<b>Subject:</b> <b>ENGINE WILL NOT START IN P-RANGE INTERMITTENTLY</b>	<b>Bulletin No:</b> 05-012/08
	<b>Last Issued:</b> 11/13/2008

2004-2008 Mazda3 vehicles with VINs lower than JM1BK\*\*\*\* \*\* 848579 (produced before November 1, 2007)

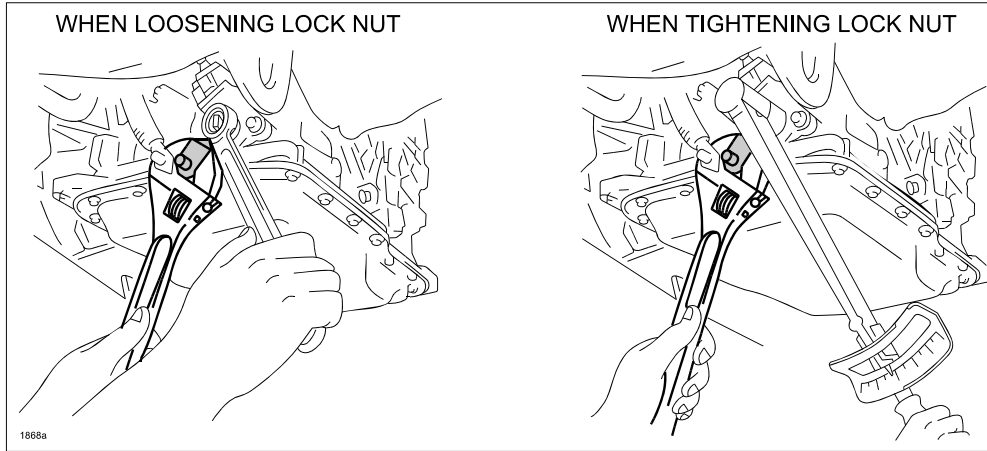
1. Verify customer concern.
2. First verify that rust appears on the connecting point of the shift cable (A) and lock cable lever (B), then replace the lock cable lever with modified one by removing the nut (C) and washer (D). Also, replace the nut and washer.

- When removing or installing the lock nut, always be sure to hold the lock cable lever with an adjustable wrench. Failure to use an adjustable wrench may cause TR switch breakage.
- If corrosion is present, apply penetrating oil to the shaft and nut threads before loosening.
- When loosening, if there is binding because of corrosion on the threads, work the nut back and forth until it comes off.

**Tightening Torque: 31.4 Nm (3.2 - 4.7 kgf-m, 23.2 - 33.9 ft. lbf.)**

Part Number	Description	Qty.
B2YE-46-310	Lock Cable Lever	1
99922-1400	Nut	1
99971-1400	Washer	1
